**NEBRASKA ARMY NATIONAL GUARD
LINCOLN COMPLEX, FMS#1 SUSTAINMENT PROJECT**

PROJECT NO. 31100108

ADDENDUM NO. 1

From Sheet: C-102	for CA use:
Drawing # C-102.1

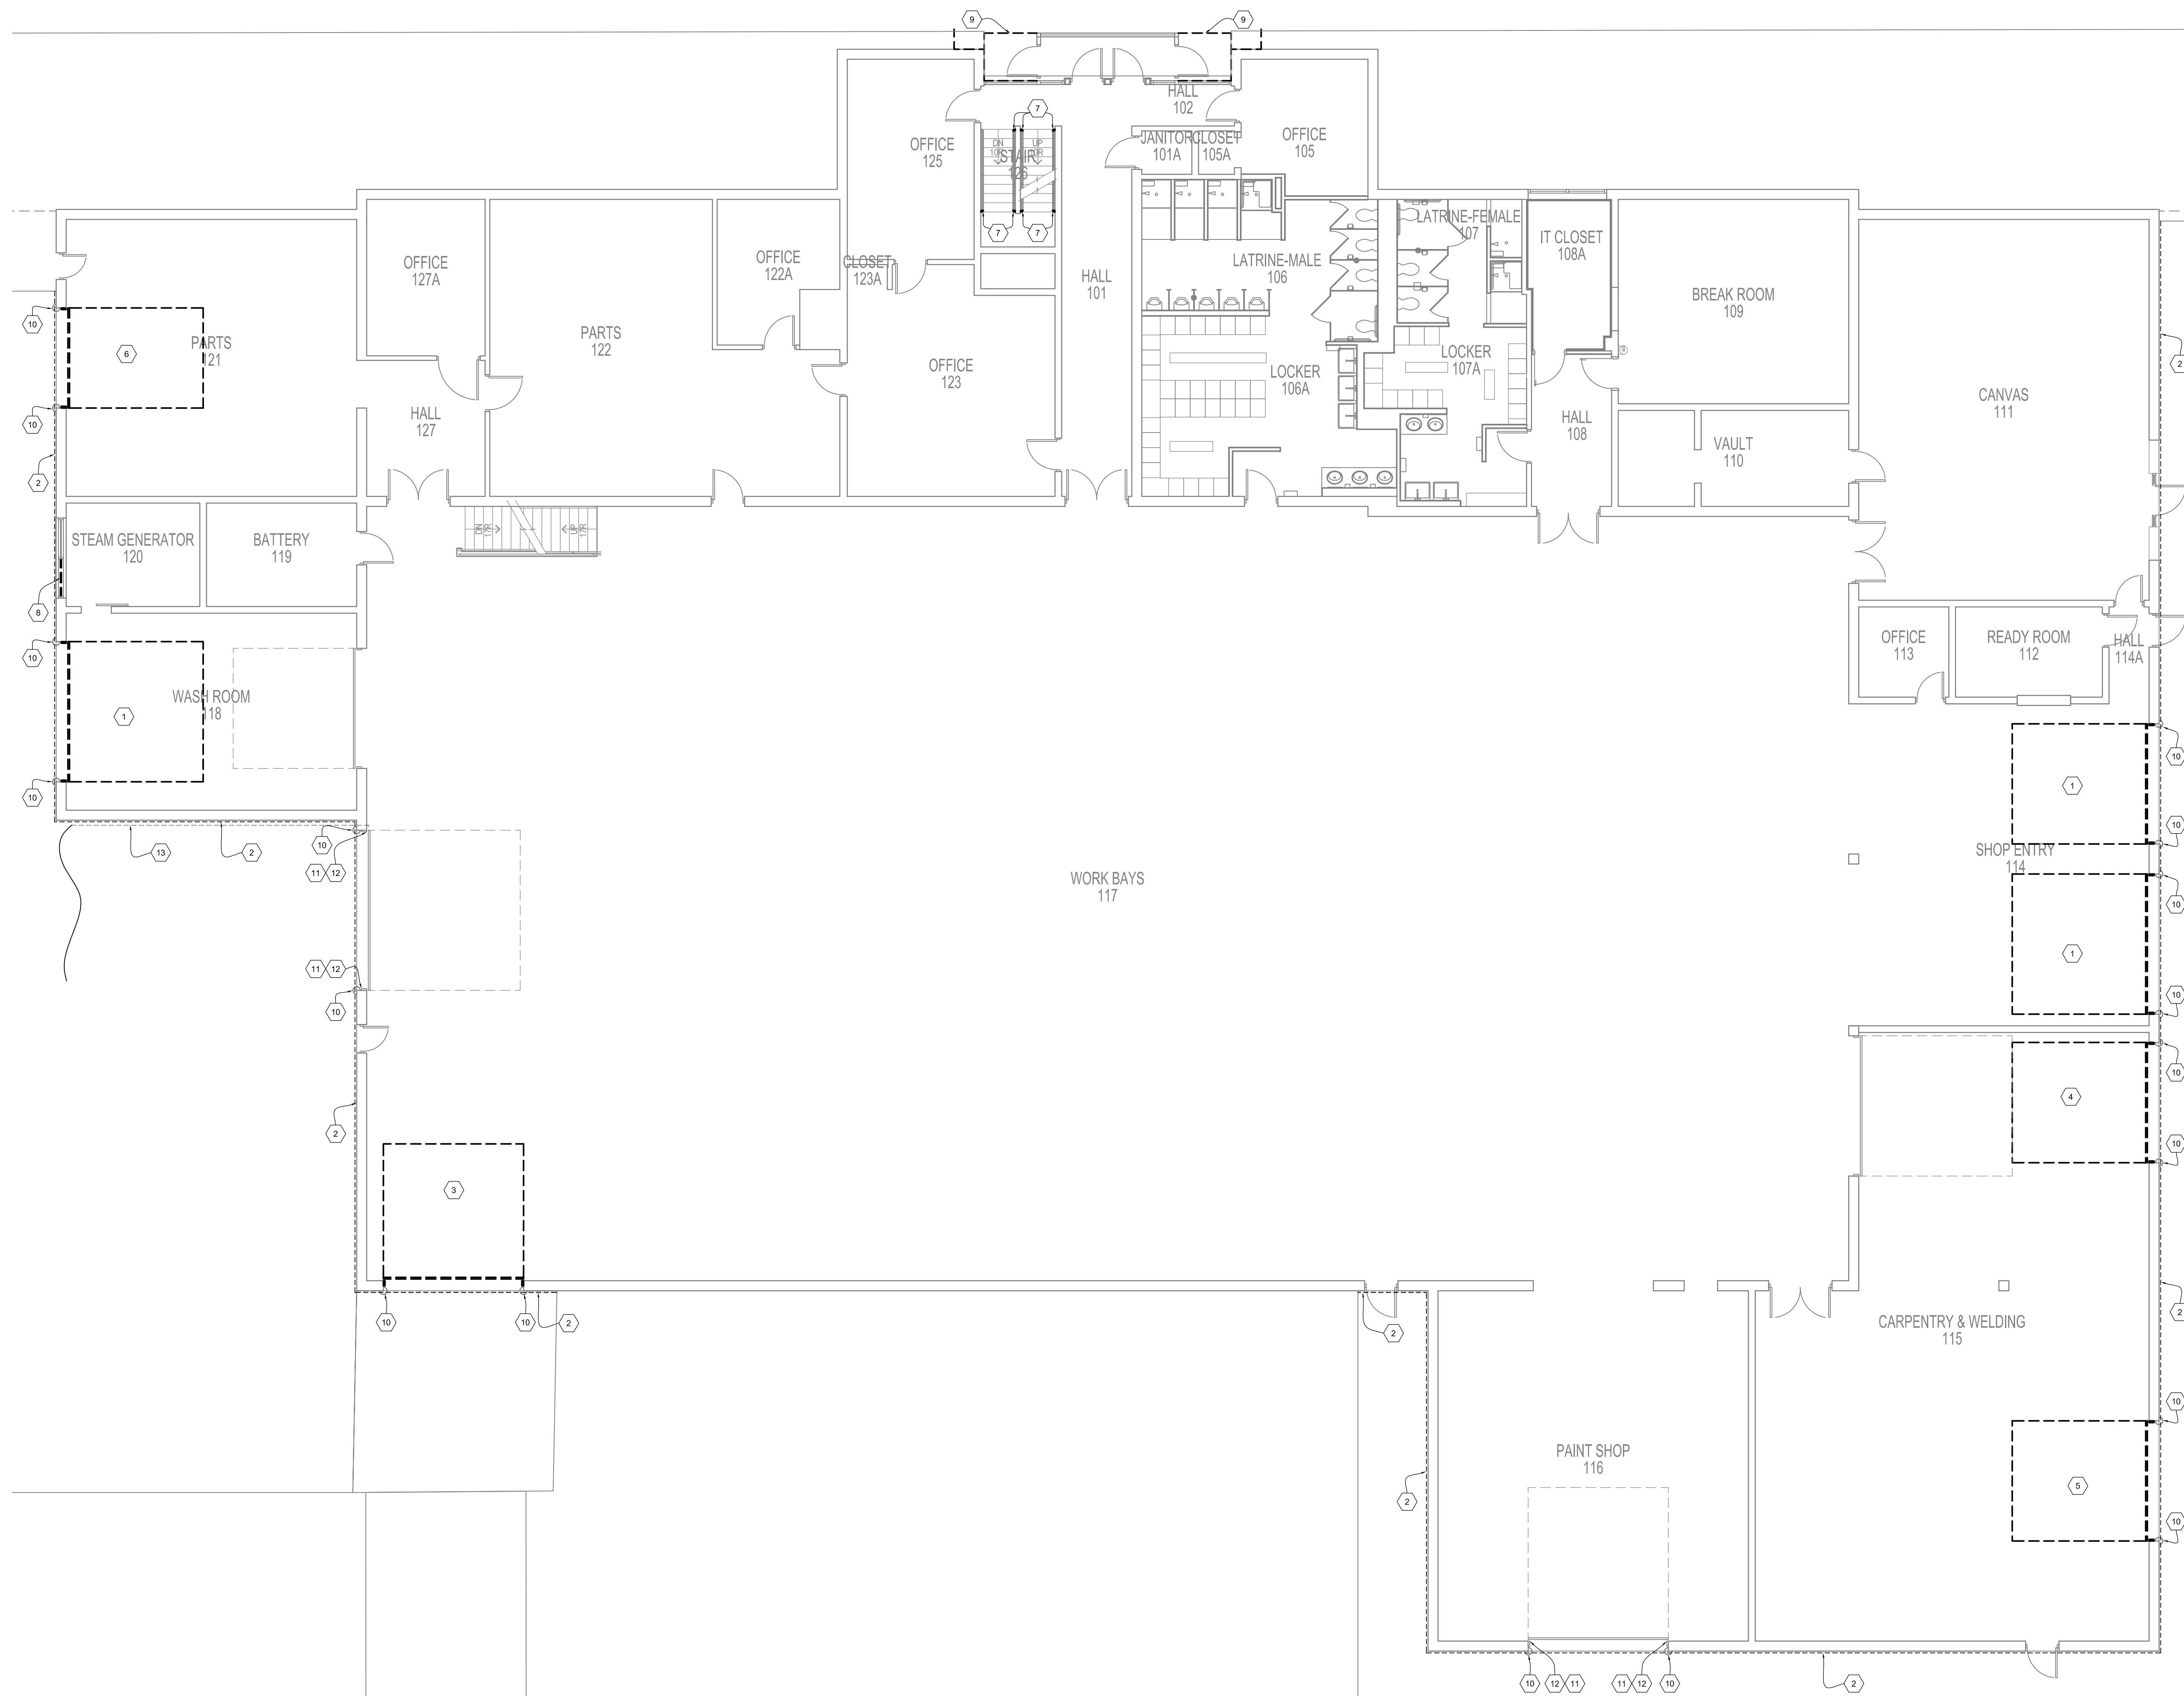
- ADD 1-9: In reference to Sheet C-102 and the attached supplemental drawing C-102.1. Add keynote #1 and point to the entire south fence line. This supplemental drawing indicates the location and length of fence removal.

SHEET NUMBER
A-101

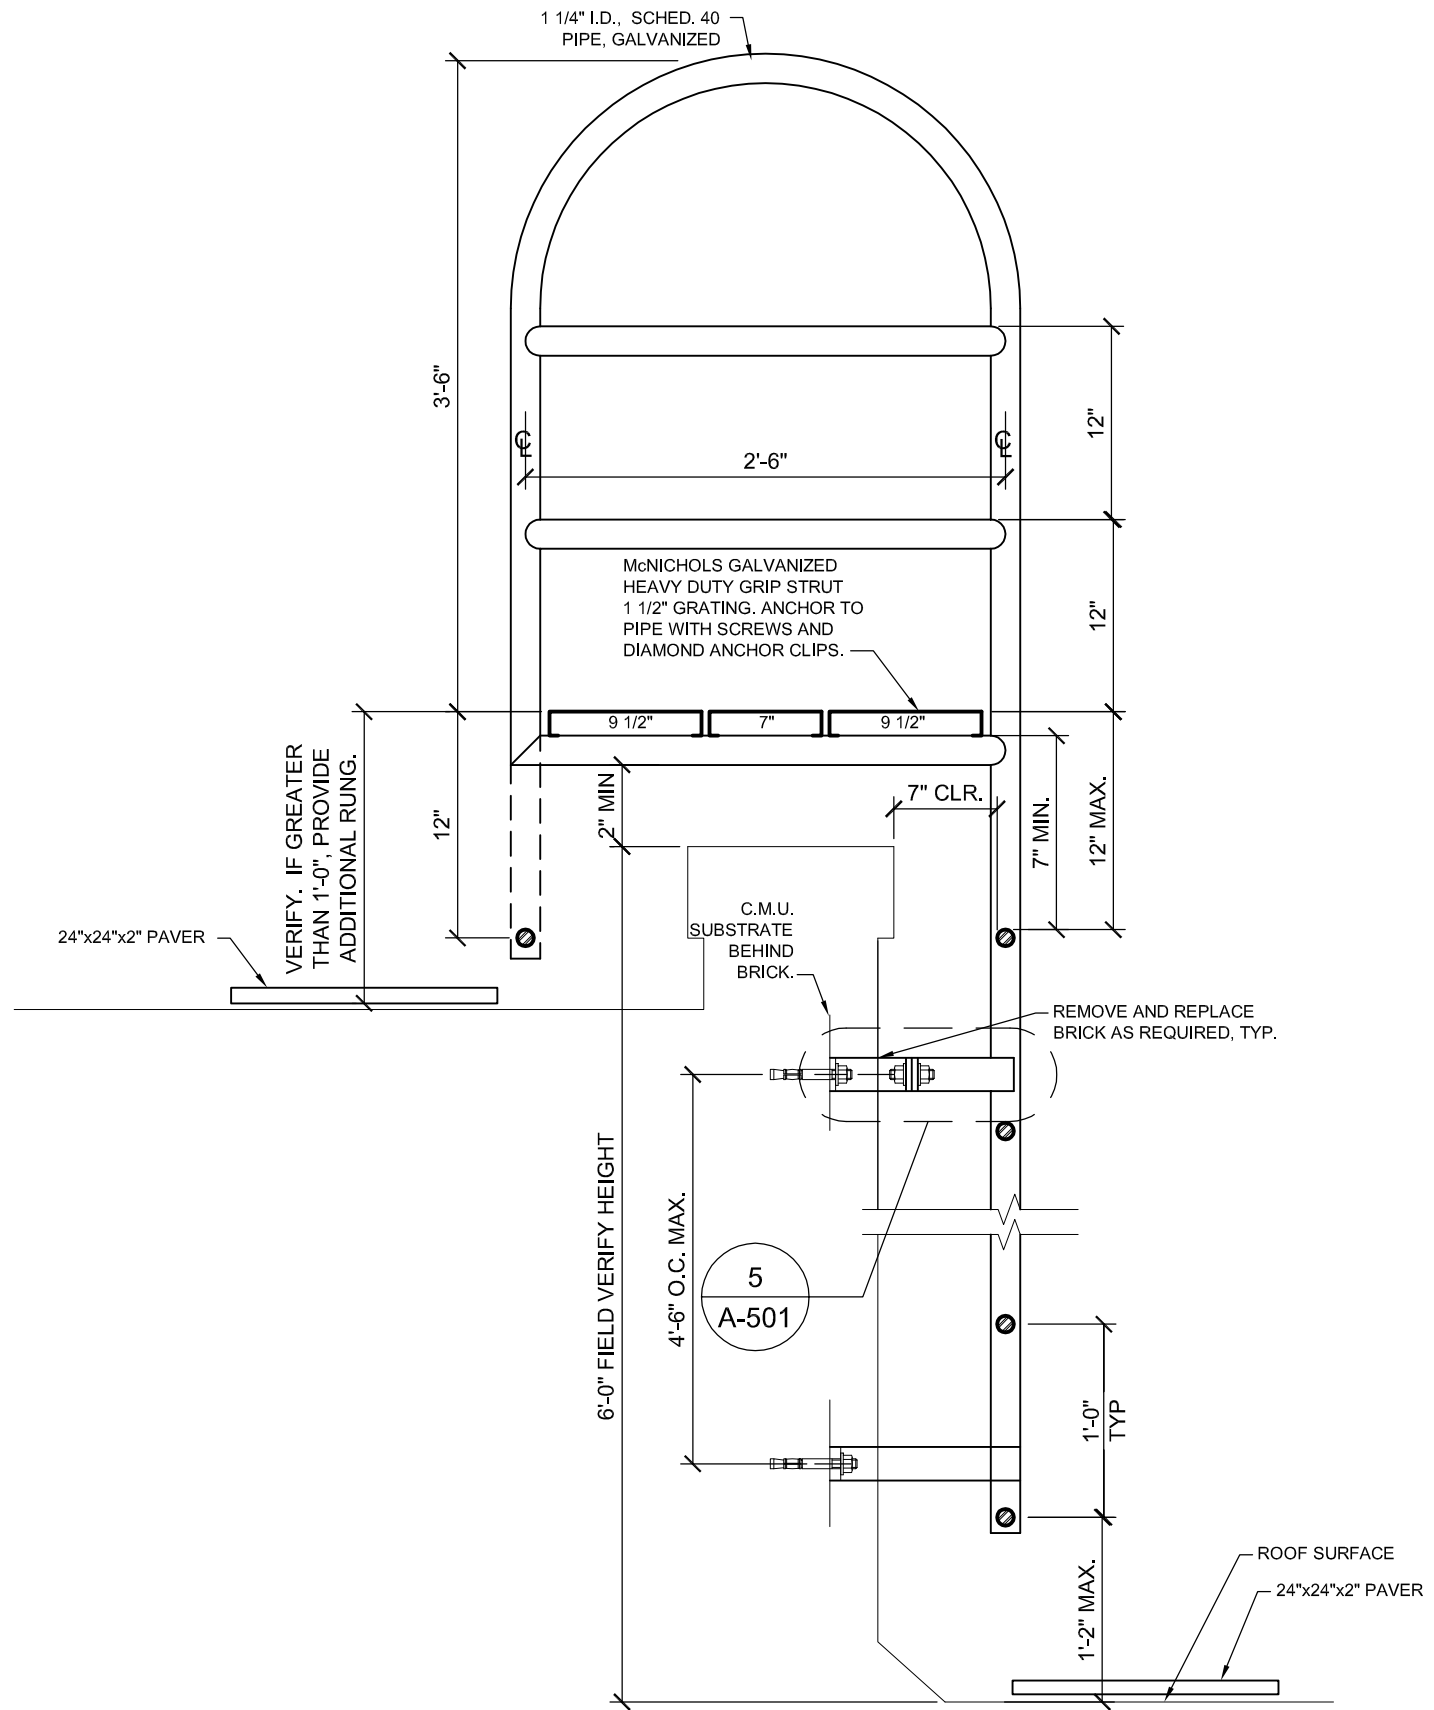
- ADD 1-13: Replace Sheet A-101 with the attached Sheet A-101.
- ADD 1-14: In reference to Sheet A-102. Add keynote #6 to the keynote beginning with "The existing....."

From Sheet:	A-501	for CA use:
Drawing #	A-501.1

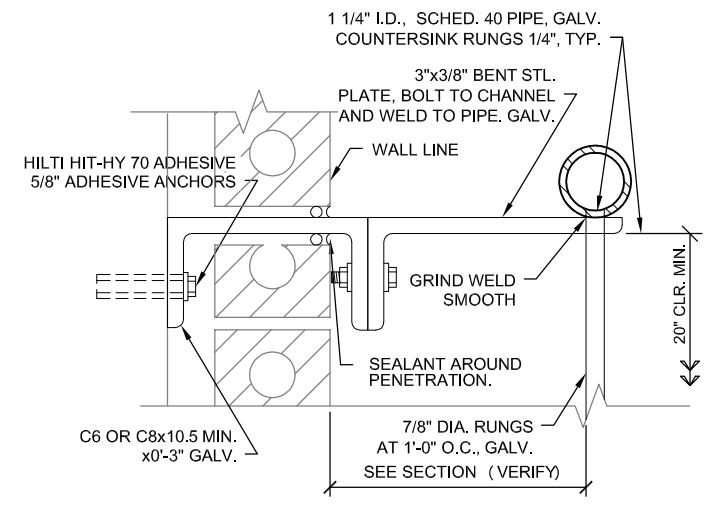
- ADD 1-15: In reference to Sheet A-102. The 2 ladders just outside the "open to work bay" area indicated by keynote #2 that are being removed are to be replaced. Install in existing location. Refer to attached supplemental drawing A-501.1 for new ladder details.
